Access Compliance Report Public Rights-of-Way (Curb Ramps)

Main Street: SANTA_CLARA_AVE Cross Street: MALENA_DR Location: SE

ADA ID: RPAT211019100949 Ramp Type: Type 1 - Perpendicular Diagonal Initial Pass/Fail: Pass Overall Compliance: No Severity Score: 0

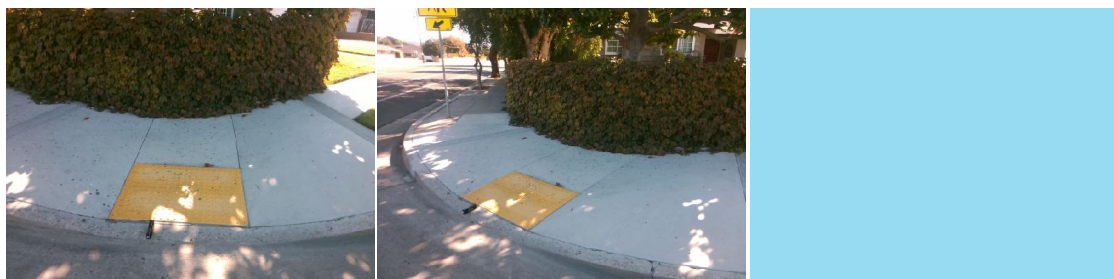
OC Std/PROW:

R304.2.1, STD 1115

Possible Solutions:

Remove & Replace Landing.
